LIST OF PROPOSED CHANGES:

THE MEADOWLANDS - PROPOSED SITE PLAN CHANGES

BUILDING 1 & 2
 PROPOSED CHANGES - FLOOR PLAN

4 PARTIAL EAST ELEVATION - BLDG 1 - CURRENT APPROVED DESIGN
 BUILDING 1 - ZONE B SHOWN
 BUILDING 2 - ZONE D SIMILAR
 1/8" = 1'-0"

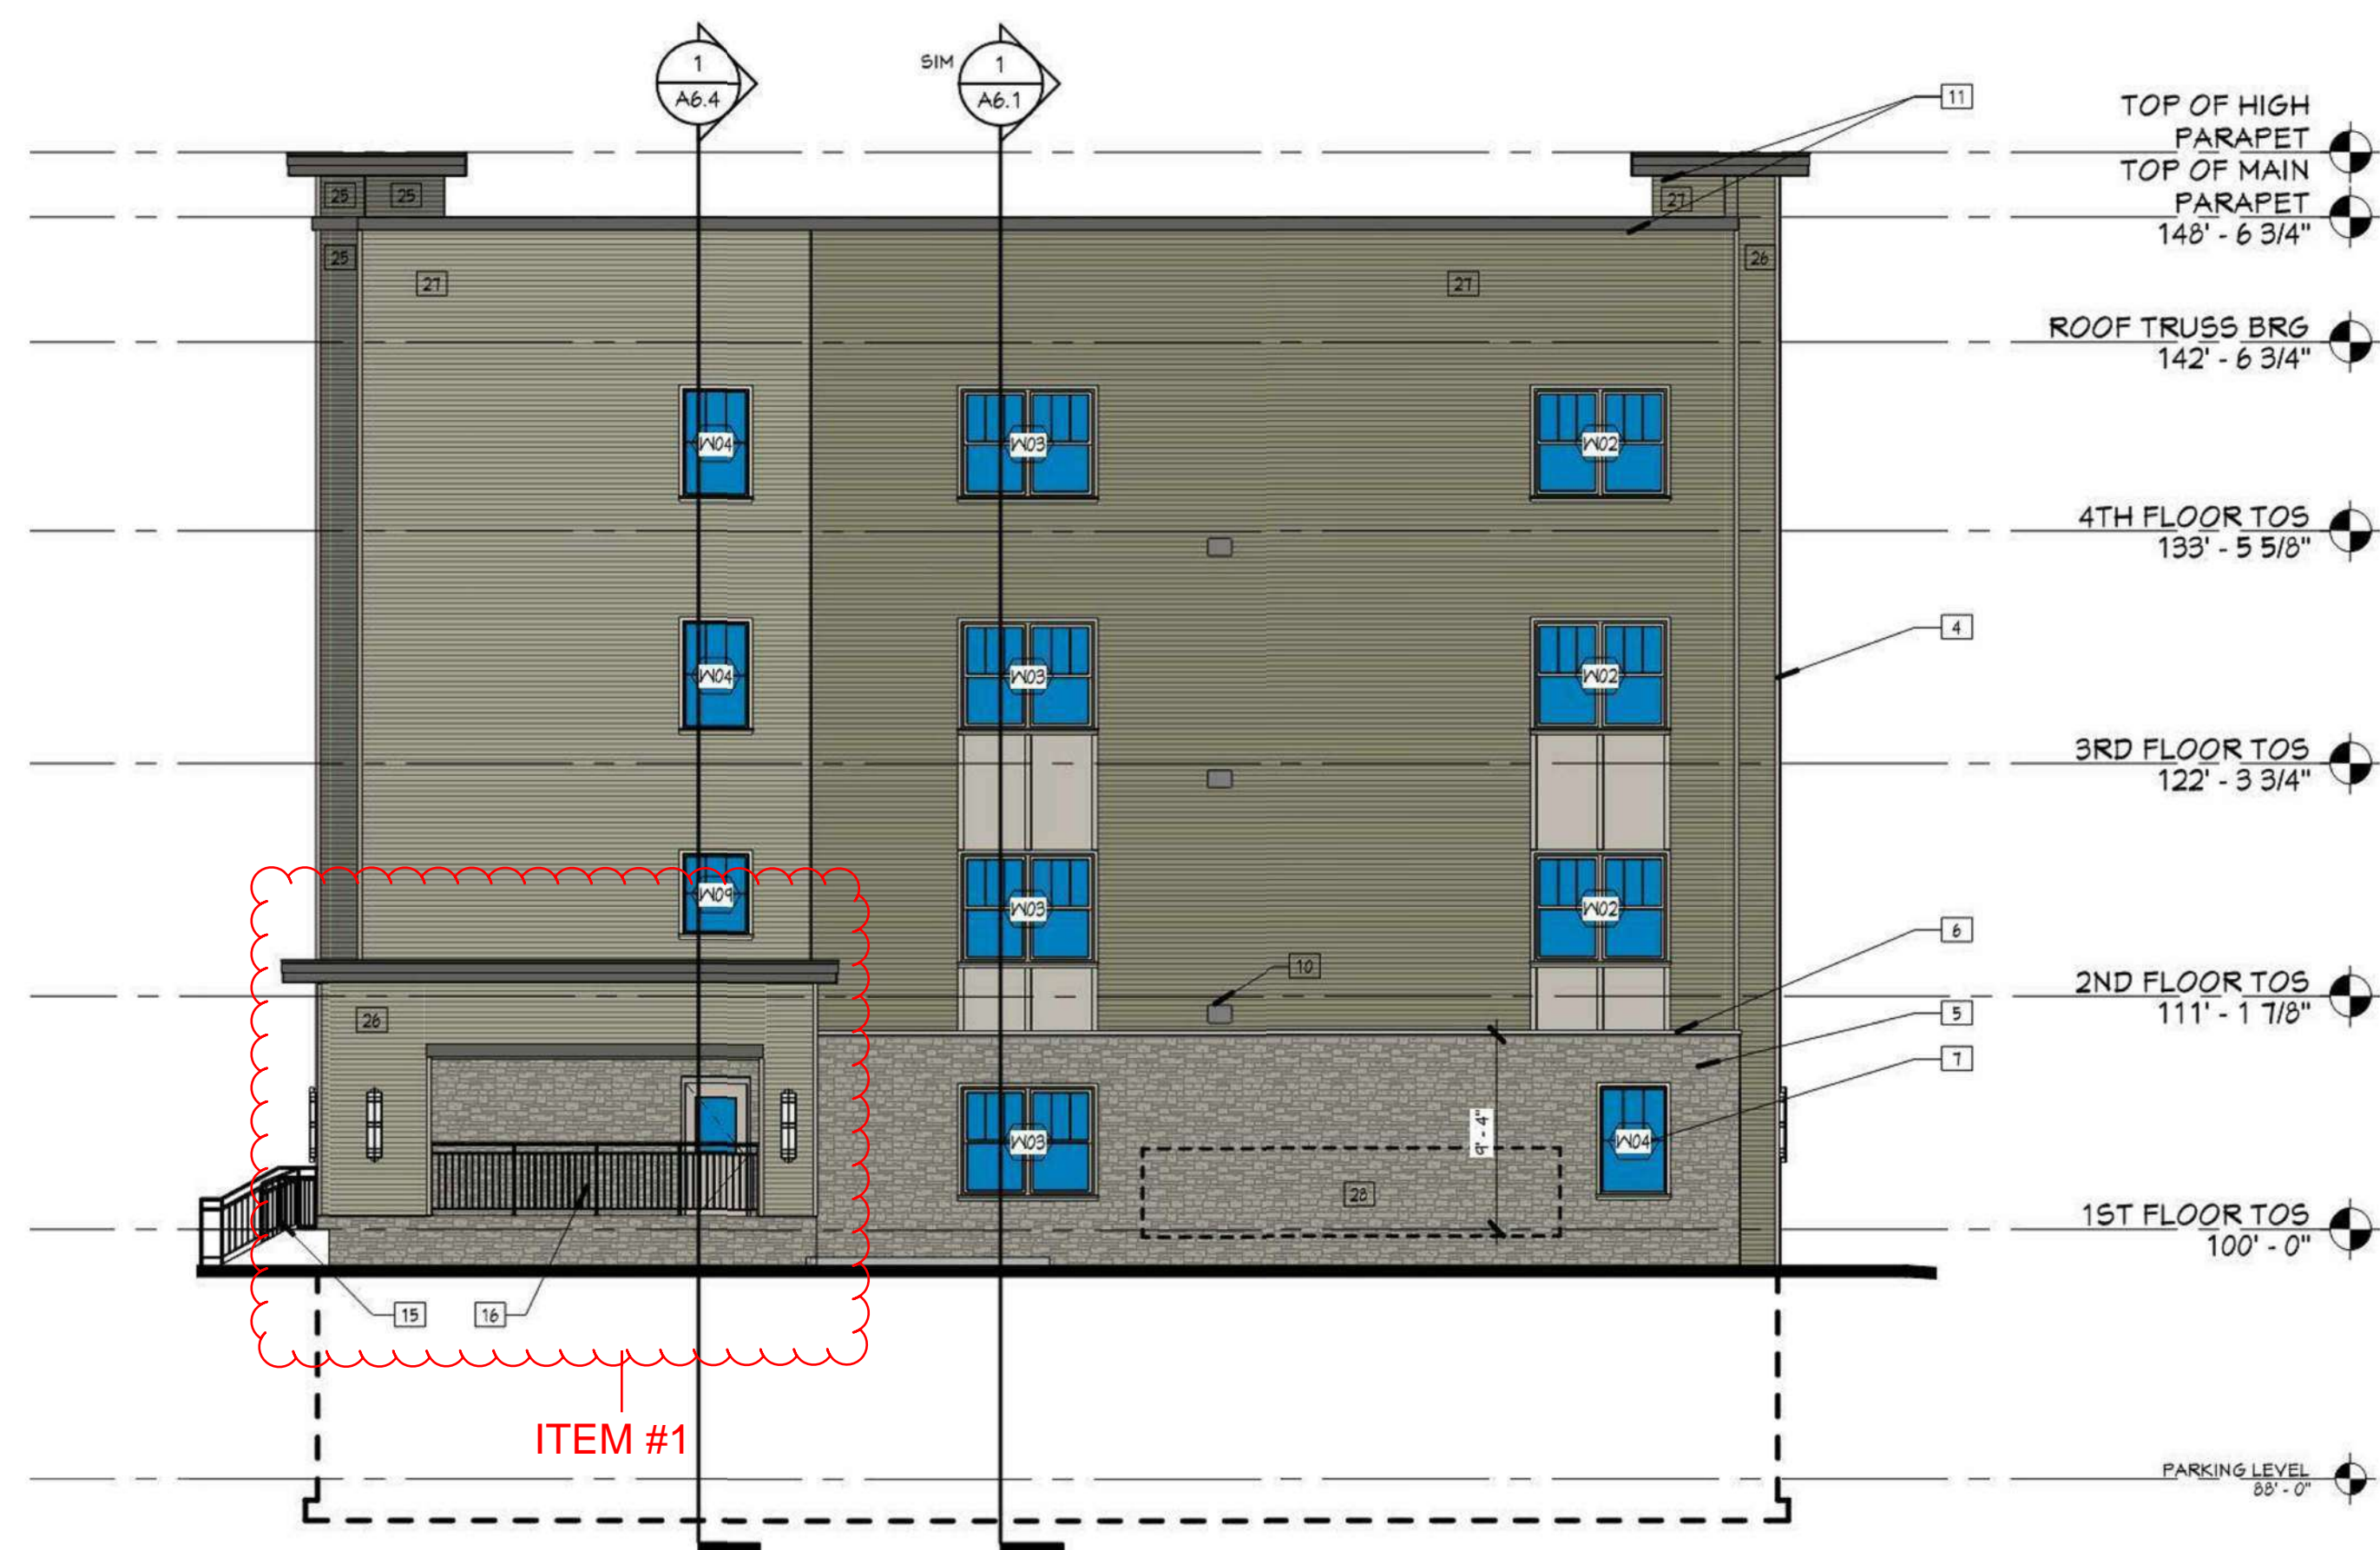
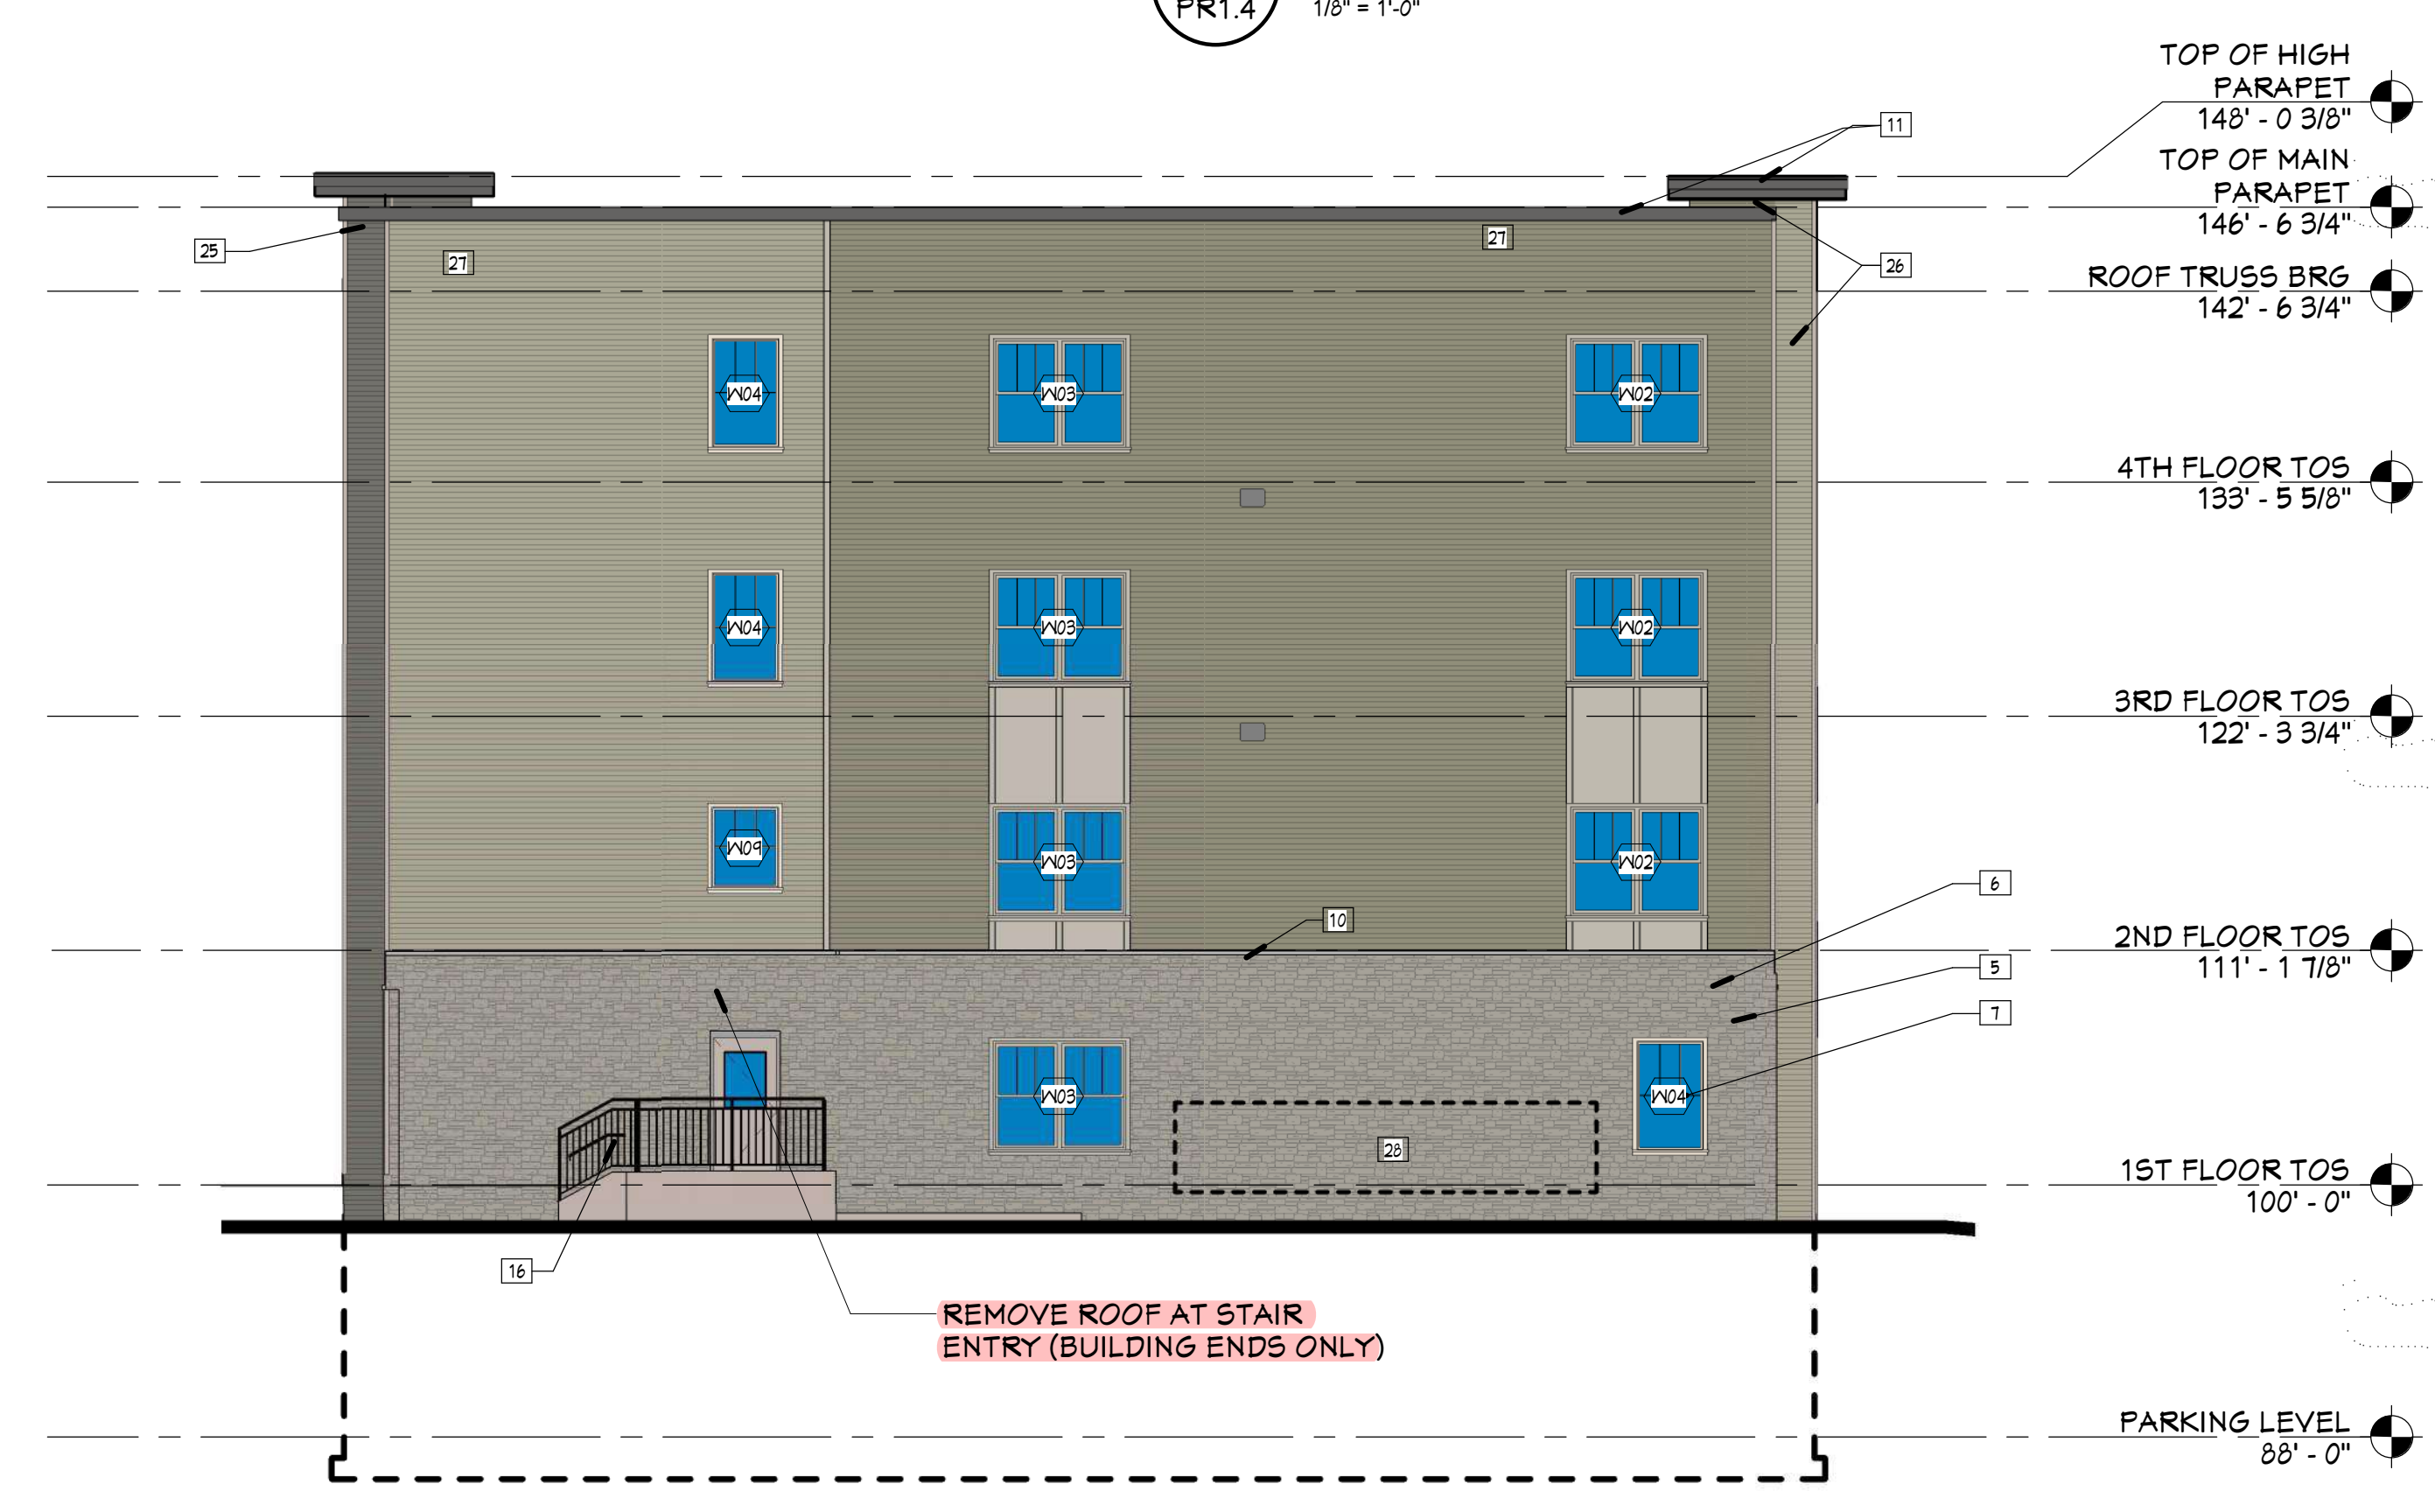
- ITEM 1: REMOVE ROOF TO PORCH AT STAIR ENTRIES AND REDUCE PORCH SIZE (TYPICAL OF ALL END BUILDINGS).
- ITEM 4: REMOVE STEPS LEADING TO PRIVATE FIRST FLOOR PATIOS AND THE ASSOCIATED RETAINING WALLS AND SIDEWALKS.
- ITEM 5: EXTERIOR LIGHTING - REMOVE DECORATIVE SCOFFCES, LIGHT TO BE PLACED IN SOFFIT ABOVE WHERE APPLICABLE.
